KNIFE RIVER ELBEE BEND BANK STABILIZATION
KNRI 257081

Elbee Bend Bank Stabilization Project, Knife River Indian Villages National Historic Site, Stanton, ND.

SHEET	SUB SHEET	TITLE OF SHEET
1	G1	COVER
2	G2	GENERAL NOTES
3	C1	EROSION CONTROL NOTES
4	V1	SITE SURVEY
5	V2	TREE SURVEY
6	C2	EROSION AND SEDIMENT CONTROL (PRE-CONSTRUCTION)
7	C3	EROSION AND SEDIMENT CONTROL (POST-CONSTRUCTION)
8	C4	OVERALL PLAN
9	C5	PLAN AND PROFILE (PROPOSED CENTERLINE)
10	C6	PLAN AND PROFILE (DRAINAGE FEATURES)
11	C7	ALIGNMENT CONTROL TABLES
12-13	C8-C9	CROSS SECTIONS
14	L1	LANDSCAPING PLAN
15-21	C10-C16	DETAILS

DRAWING NO. 468 184187
PMIS/PKG NO. KNRI 257081
SHEET 1 OF 21

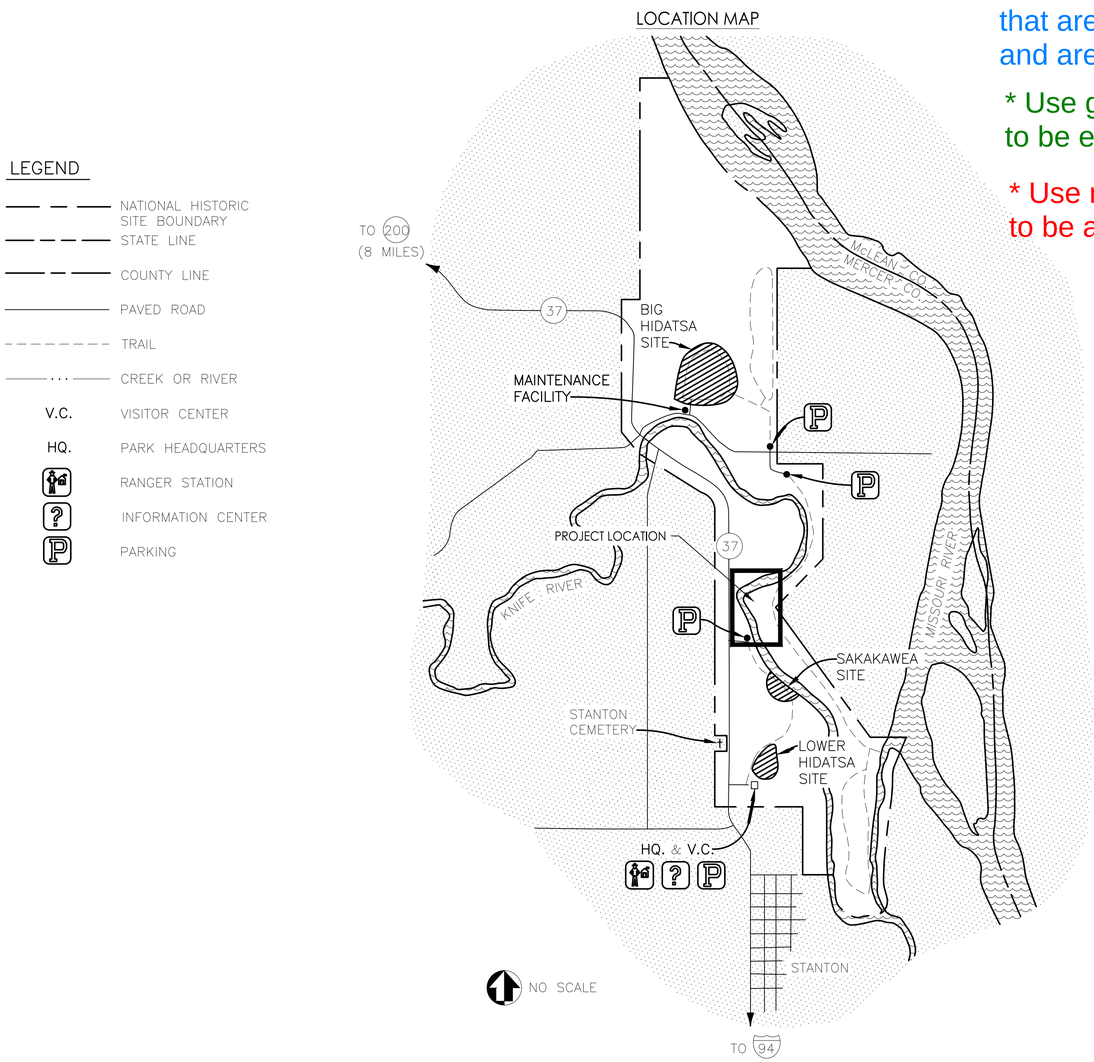
Add Pat's ND PE Stamp signature and date (blue pen)

A/E FIRM PRIME/CIVIL STANTEC CONSULTING SERVICES INC. DENVER, CO	DESIGNED: PTP CADD JMM TECH. REVIEW: JGG DATE: 12/13/2024	SUB SHEET NO. C2	TITLE OF SHEET KNIFE RIVER ESC PRE-CONSTRUCTION KNIFE RIVER INDIAN VILLAGES N.H.S.	DRAWING NO. 468 184187 PMIS/PKG NO. 257081 SHEET 6 OF 21

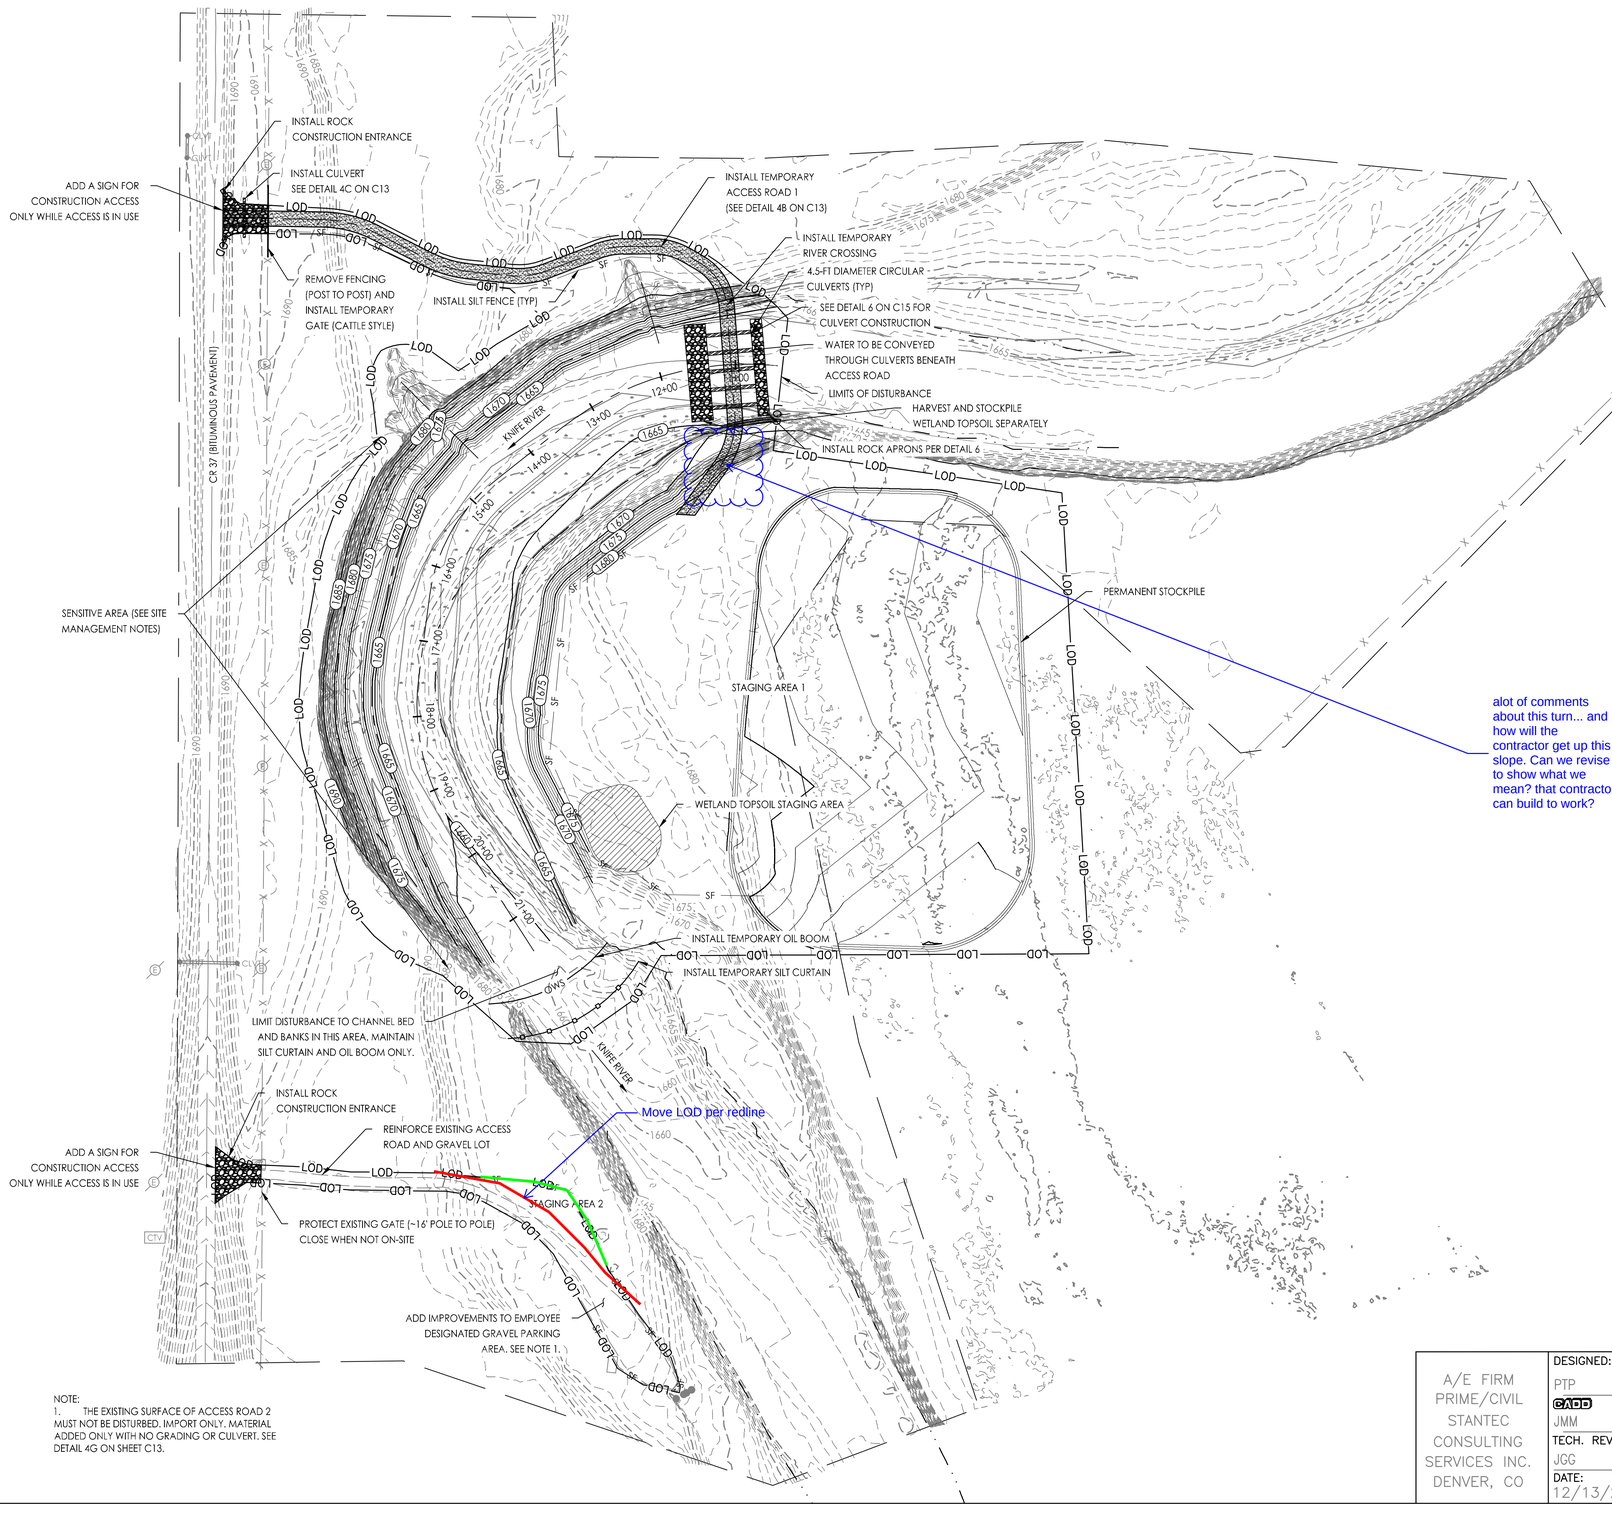
alot of comments about this turn... and how will the contractor get up this slope. Can we revise to show what we mean? that contractor can build to work?

4A 18XX16 TENSION CRACK TREATMENT
NTS

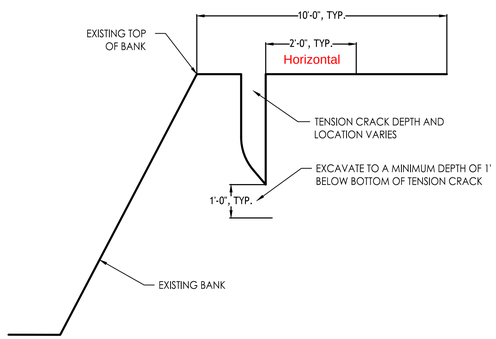
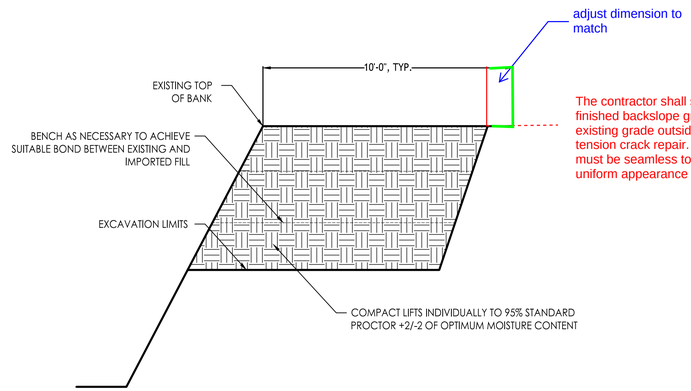
Detail 4A, section on the left, what is 2'-0", TYP noting? Section on the right, excavation limits do not align with 10'-0", TYP note, also what is backslope?

The contractor shall smooth the finished backslope grade to match the existing grade outside the area of tension crack repair. All transitions must be seamless to ensure a uniform appearance and stability.

4E 18XX6 EROSION CONTROL MATTING AND BLANKET
NTS
SHTS. 6-7

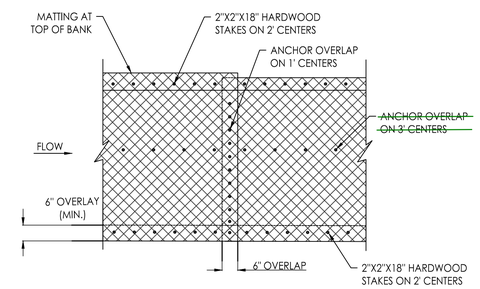
Detail 4E, edit anchor overlap notes to remove discrepancy.

7B 21 19 BURIED ROCK REFUSAL B-B'

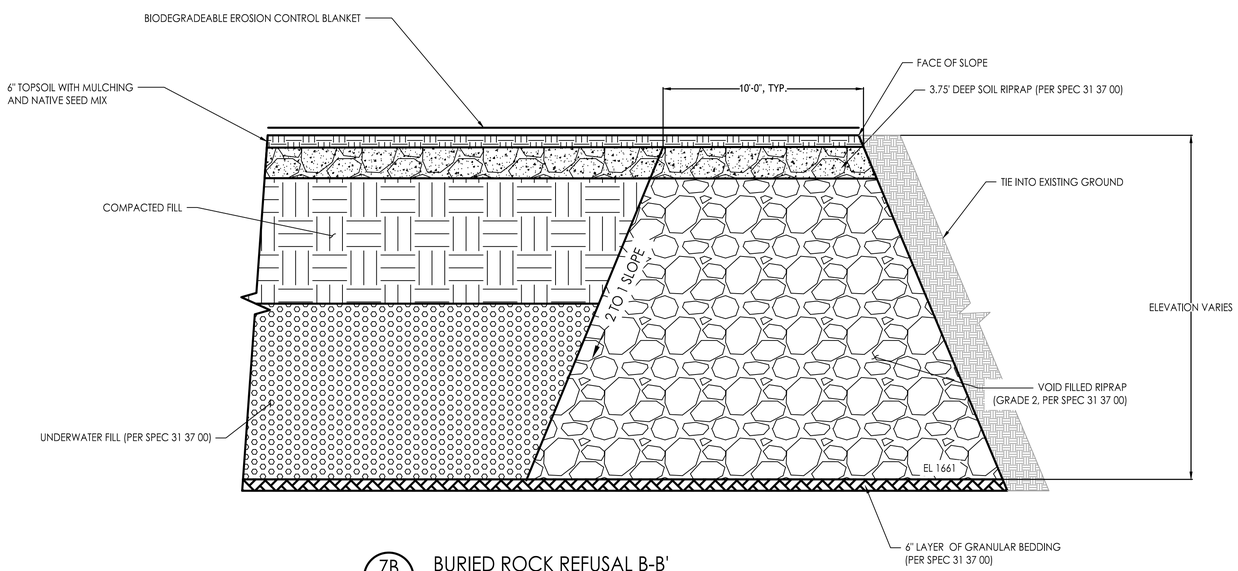
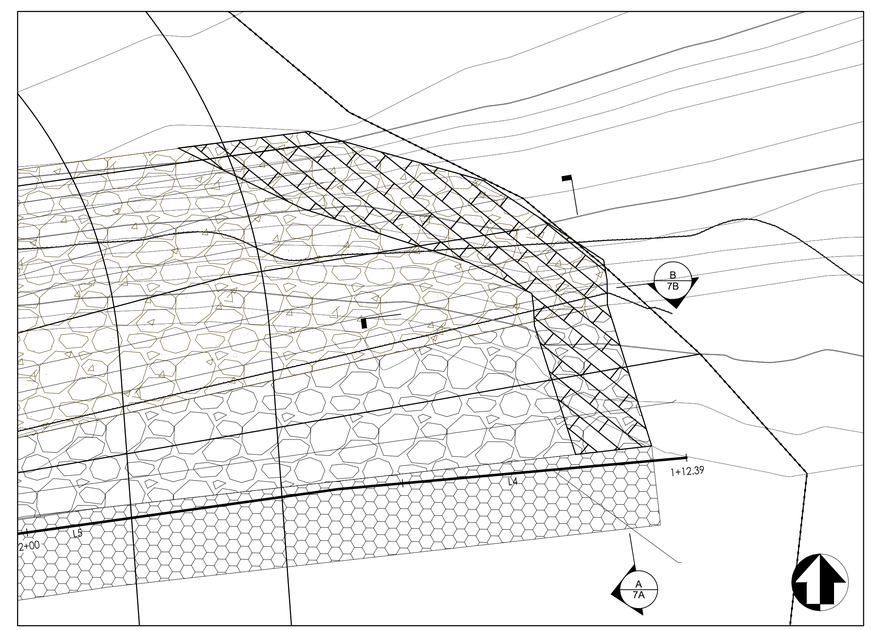
Detail 7B, On ELEVATION VARIES note, provide top elevation of Refusal as it could be 1675' if blending into top of bank contours, yielding a bottom width of greater than 66'?
